Response to Review Agencies

Surveyor's 1st Review by Shaun Rose

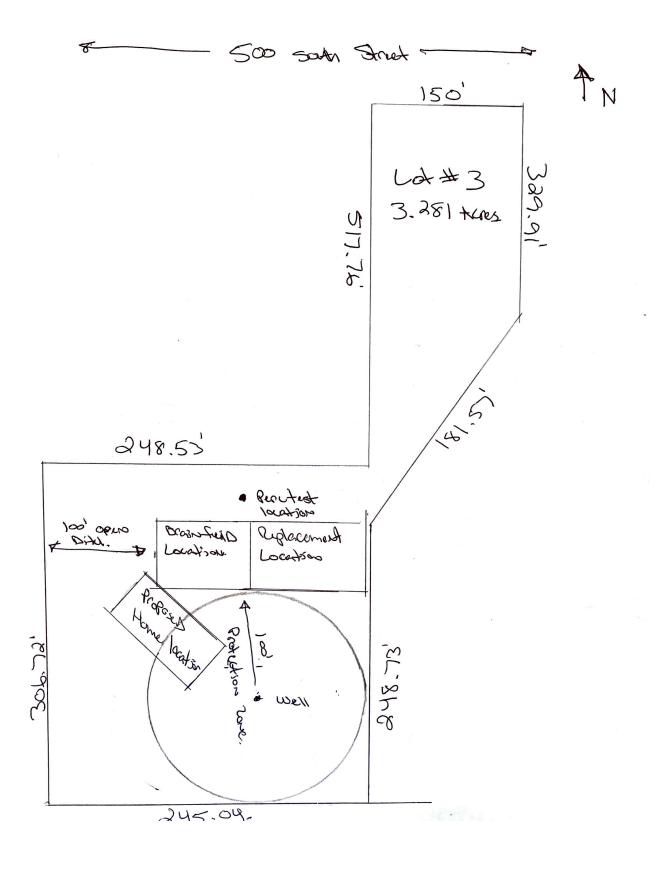
Planning Review by Felix Lleverino

Response: Felix Lleverino requested a number of corrections to our plat plan. We will ask our surveyor, Clint Whitney, to make these corrections to the plan. We will also supply Clint Whitney with the following image (see below) showing the location of our percolation test pit and the desired location of our well, the soil horizon data from the test, and the State Engineer's order regarding water allocation specific to irrigation water so that he can add that information to the plan.
